INSTRUCTION TO SERVICE ITS: 3419

OBJECTIVE/SUBJECT:

Replace hydraulic line 298746 with flex hose 321287 as per EAD-4761

Figure 1A: Hydraulic Line Removal

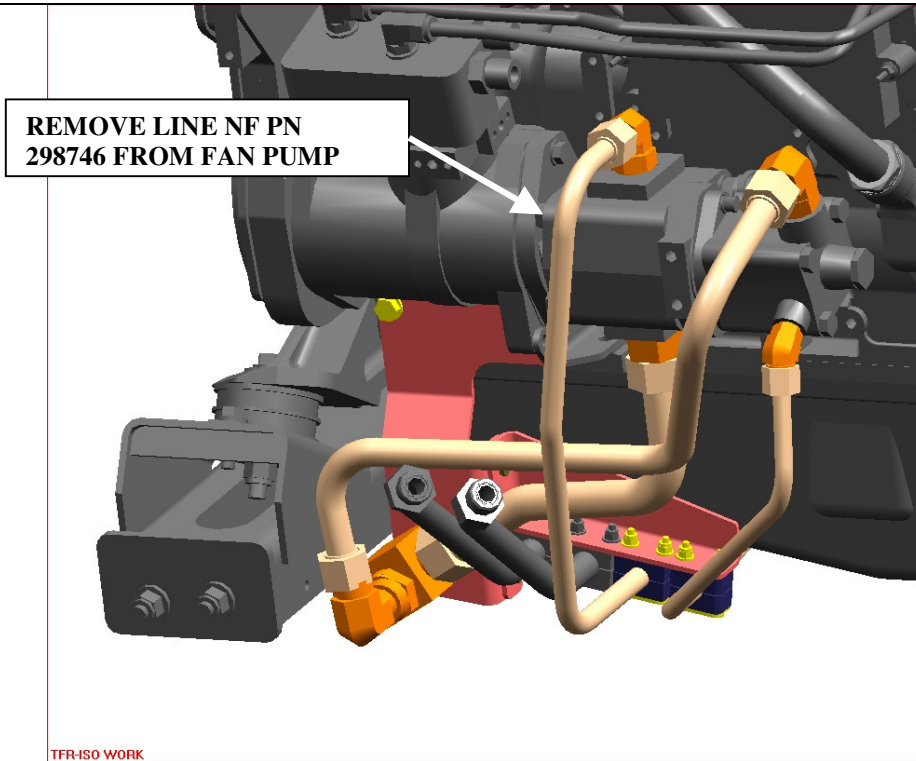
1. Turn the main battery disconnect switch to the "OFF" position.
 2. Raise coach in accordance with the New Flyer Service Manual or use a service pit.
 3. Open the rear engine access door.
- NOTE:** Place a drip tray underneath at the ends of the hydraulic line NF PN 298746 and hydraulic manifold to catch any fluid runoff.
4. Undo the clamps retaining the hydraulic line (NF PN 298746). Store hardware for reinstallation.
 5. Disconnect the hydraulic line (NF PN 298746).
 6. Disconnect the attached hydraulic line (NF PN 298793) that runs to the hydraulic manifold.

Figure 3: Hydraulic Line Replacement

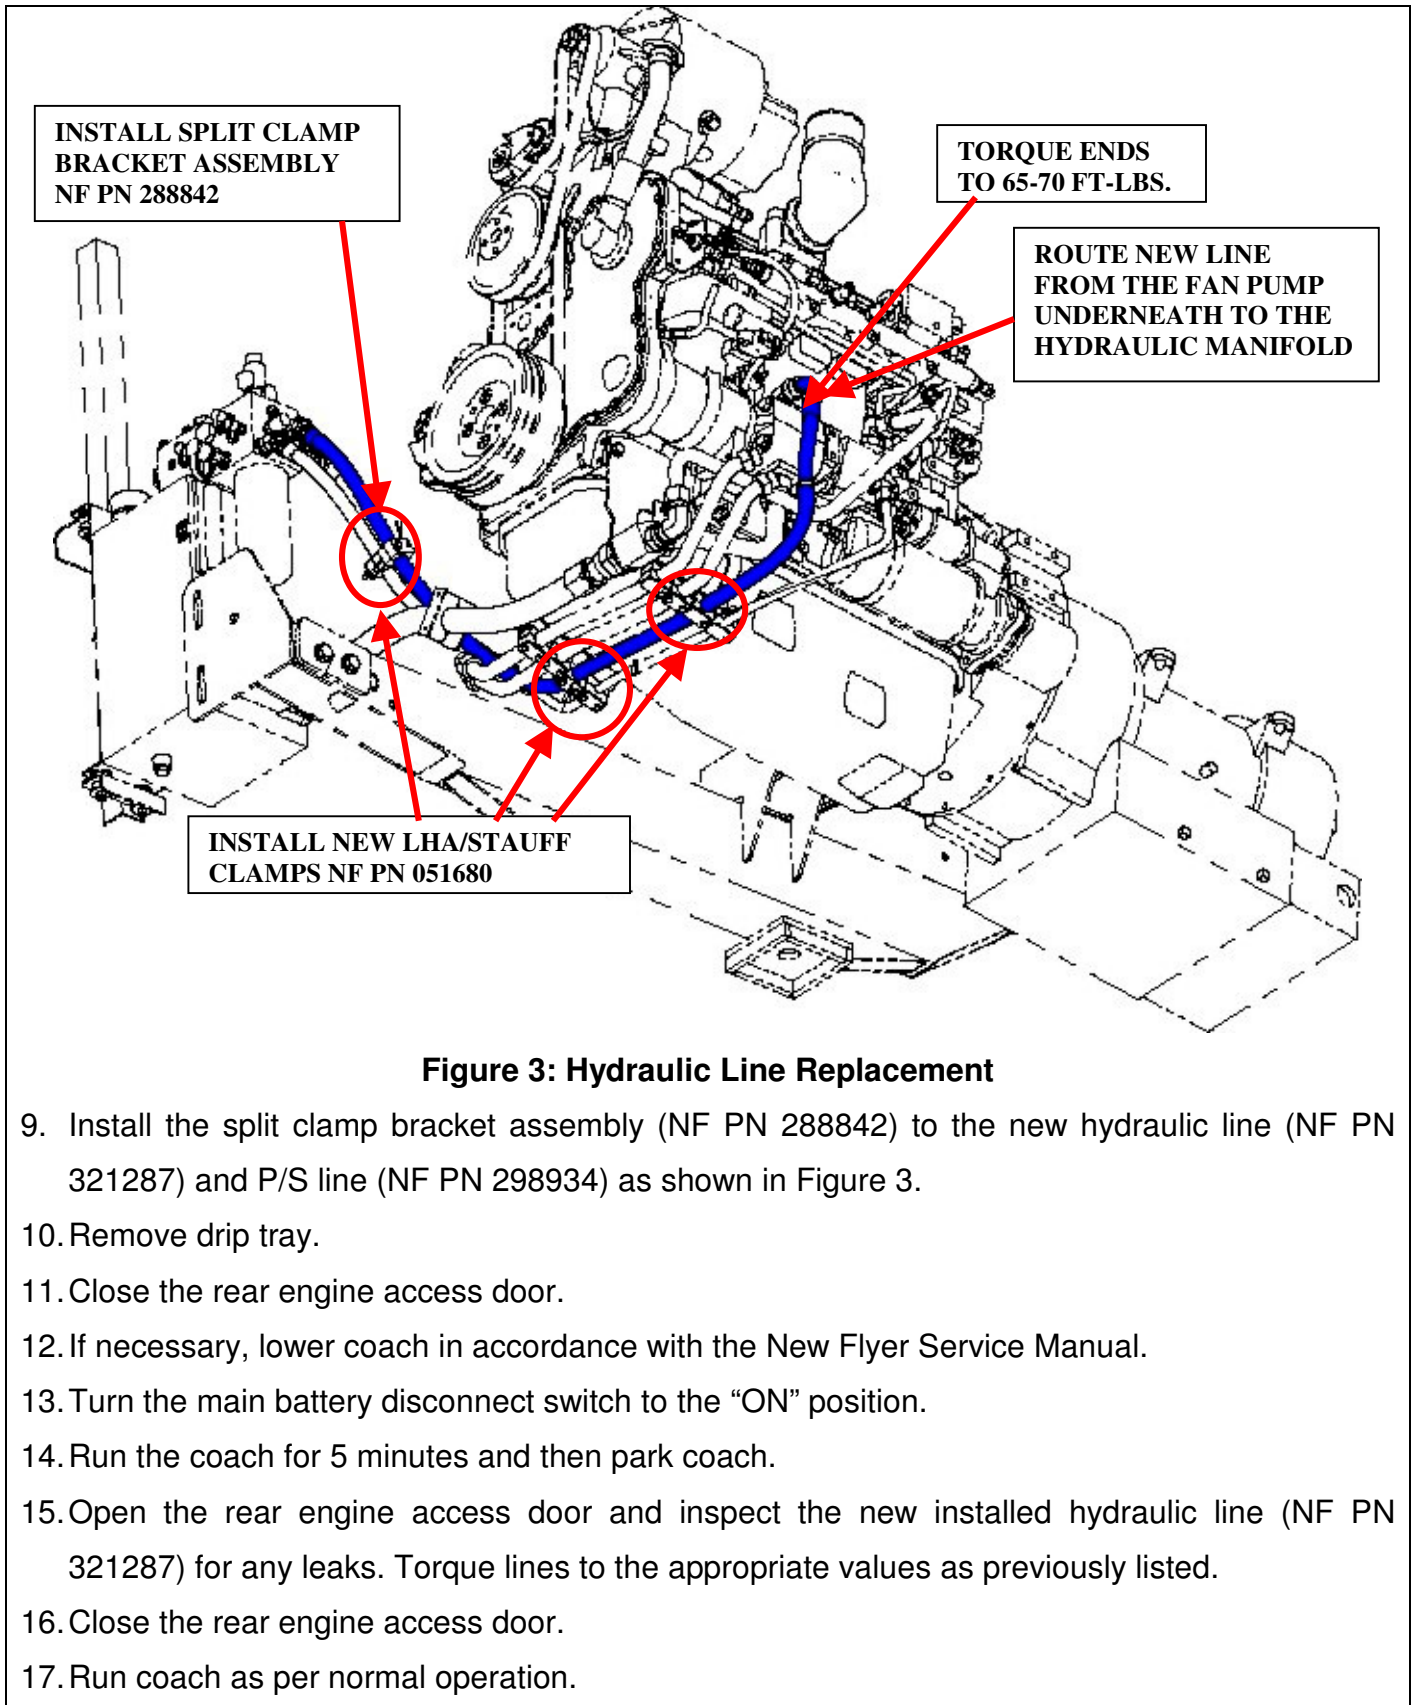
9. Install the split clamp bracket assembly (NF PN 288842) to the new hydraulic line (NF PN 321287) and P/S line (NF PN 298934) as shown in Figure 3.
10. Remove drip tray.
11. Close the rear engine access door.
12. If necessary, lower coach in accordance with the New Flyer Service Manual.
13. Turn the main battery disconnect switch to the “ON” position.
14. Run the coach for 5 minutes and then park coach.
15. Open the rear engine access door and inspect the new installed hydraulic line (NF PN 321287) for any leaks. Torque lines to the appropriate values as previously listed.
16. Close the rear engine access door.
17. Run coach as per normal operation.
